Dear Paul Stoy et al.,

I have now received the third review for your revised manuscript on methane emissions from bison. While the reviewer is not completely convinced by the responses you have given in your previous response I am confident the currently remaining issues can be clarified, particularly in terms of explaining which errors you are showing based on how many data points and how these were derived. Similarly, I suggest to address the importance of specific biological parameters on CH₄ emissions from ruminants (ie. diet quality not just quantity). Of course, there aren't many studies on bison available and this seems to be a scoping study to extend future measurements, I would like to point towards comparing your results to either "similar" species such as buffalo or cattle that are grazed even during colder periods in the year. You may further think about stressing more strongly that your system is a mix between a grazed and a feedlot system, given the supplementation with hay. With this, I am looking forward to receiving your revised manuscript.

Review of manuscript bg-2020-38-manuscript-version5

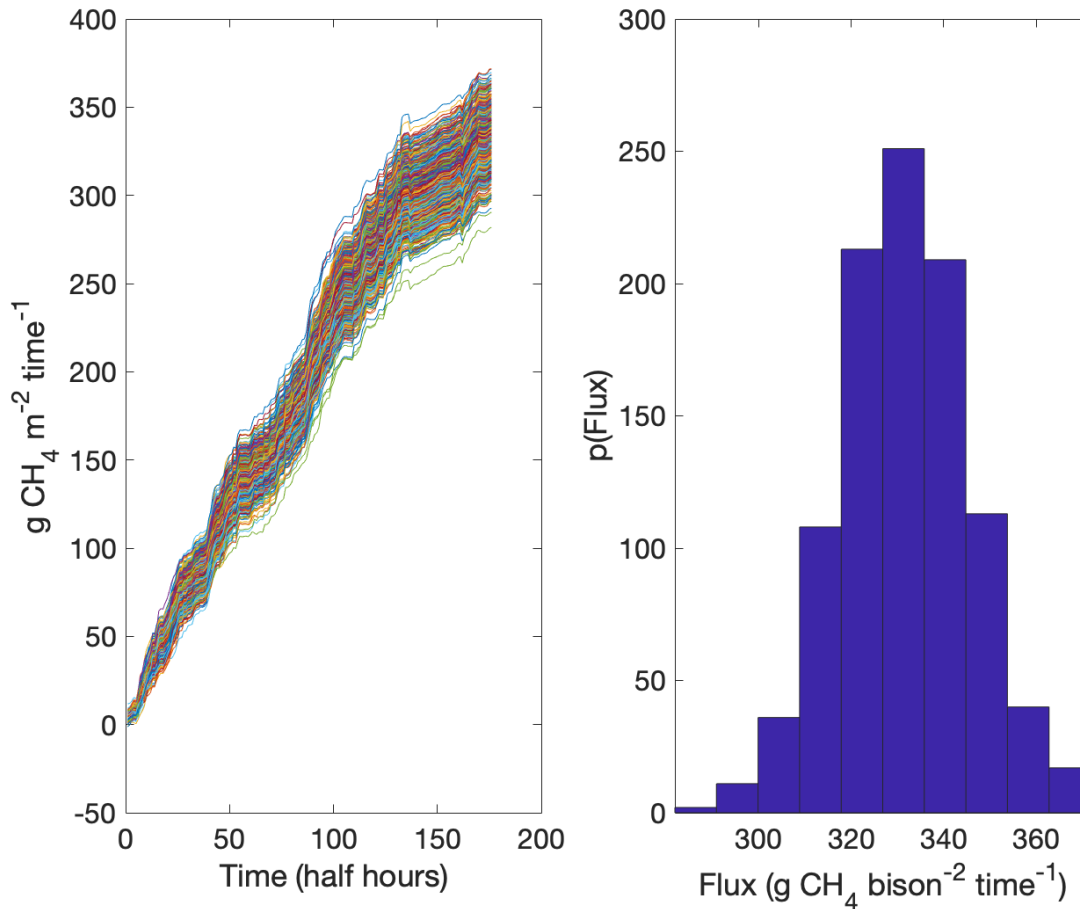
- Figure 11A shows that the individual per-bison-emission data have a strongly skewed distribution. Therefore the random-like error cannot be well estimated according to Gaussian statistics rules. However the difference between arithmetic mean and median is an indicator of a large uncertainty.

We are unaware of flux observations that follow a normal distribution and the sum of these values will approach a normal distribution due to the Central Limit Theorem. For example, the figure below demonstrates 1000 realizations of the cumulative sum of observed per-bison

methane flux with a random 41% uncertainty about each observation, which is the upper end of the uncertainty established by Deventer et al. (2019).

The cumulative sums, right, are normally distributed. We would agree that our observations are not strictly speaking independent as the central limit theorem requires, but we feel that it is a reasonable approximation.

Performing this analysis inspired us to reinterpret the uncertainty analysis using approaches that are perhaps a bit more established in flux science. We calculated the mean percent uncertainty for the spatial uncertainty analysis, the flux footprint analysis (without spatial uncertainty), and the 41% conservative uncertainty estimate of flux sums following Deventer et al. (2019). We used these percent uncertainties to calculate a variance for each observation, then drew 1000 samples from each of these distributions to create different realizations of the sum of fluxes as demonstrated above. We then calculated 95% confidence intervals about the flux sums and present these in the revised manuscript rather than standard deviations or variances. The percent uncertainty that we now calculate for each term differs slightly from previous uncertainty estimates as a result, but results do not change our conclusions.
